# TECHNICAL SERVICE INFORMATION

MODEL	F(L)115B
SUBJECT	FIELD CORRECTION FOR THROTTLE BODY BRACKET

## FIELD CORRECTION

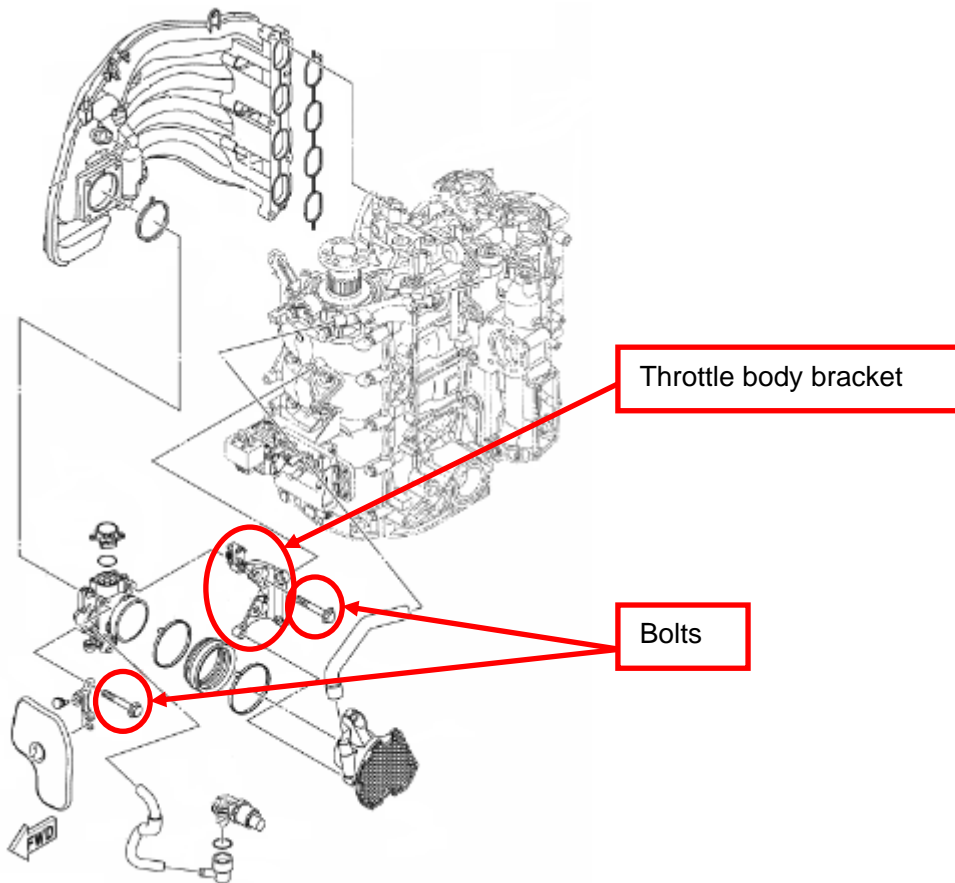
The throttle body bracket fitted on the above-mentioned model has been found to be defective. While the engine is running, the throttle body bracket may break due to engine vibration and the main harness may lose its electrical continuity to ground, causing the engine to stop or become unable to restart. To prevent this problem from happening, field corrections will be performed to replace the throttle body bracket on the above-mentioned model with a new, countermeasure part.

Replace the throttle body bracket and throttle body bracket bolts with new, countermeasure parts.

## <Part Number Changes and Interchangeability>

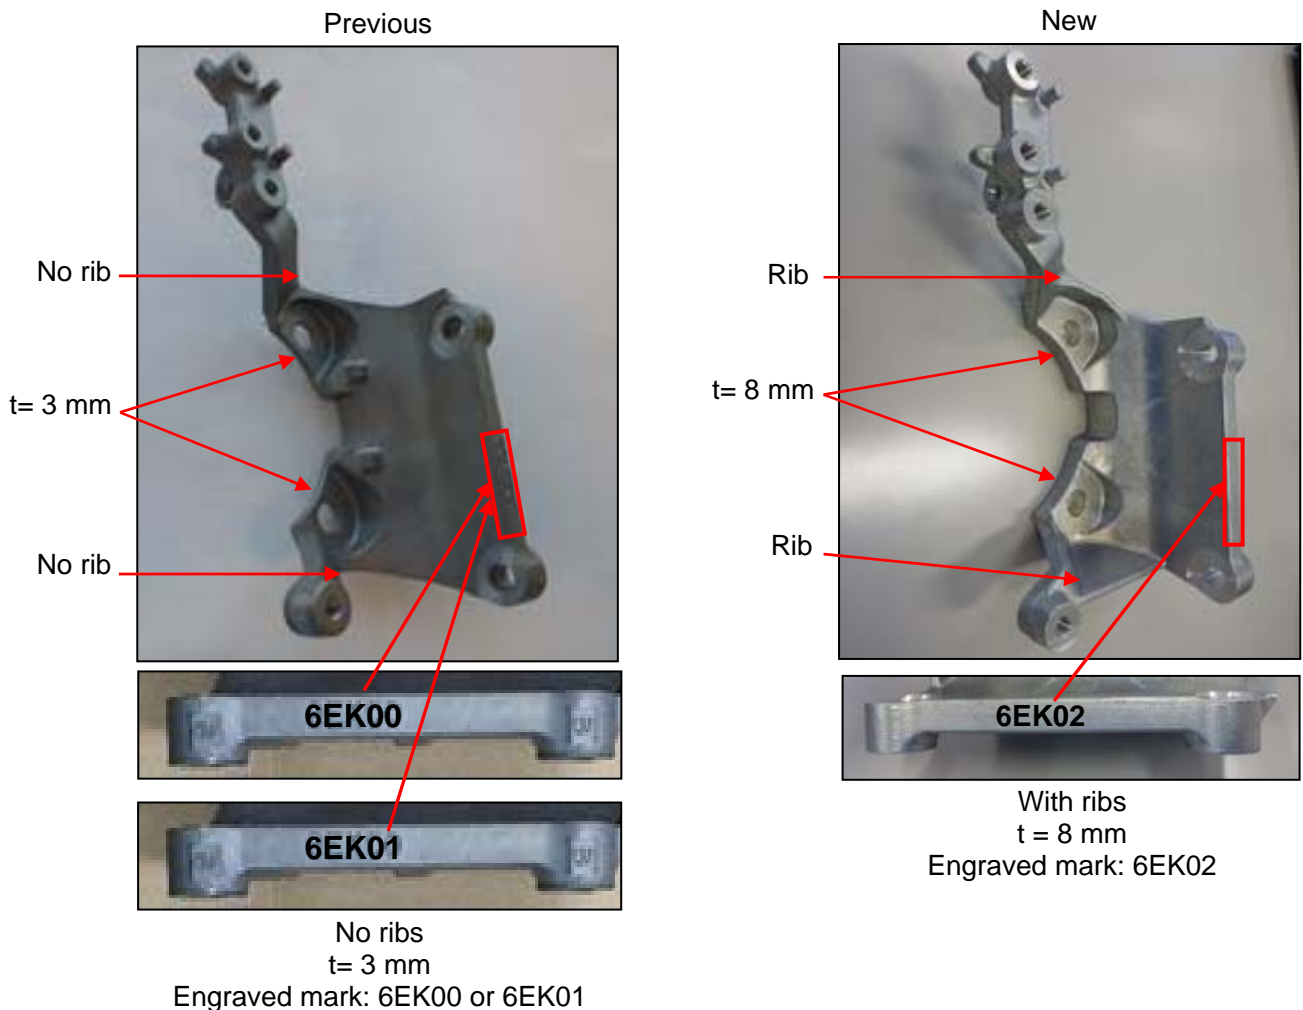
Part name	Part number	Q'ty
STAY 2 KIT	90891-40850	1
STAY 2	•6EK-13152-02 *1	1
BOLT, FLANGE	•90105-08186 *1	2
BOLT, FLANGE	•95875-08060 *1	1

\*2. Dimensions of both BOLT, FLANGE (90105-08186) and BOLT, FLANGE (95875-08060) are shown below. Make sure to distinguish properly between the two types of bolts.
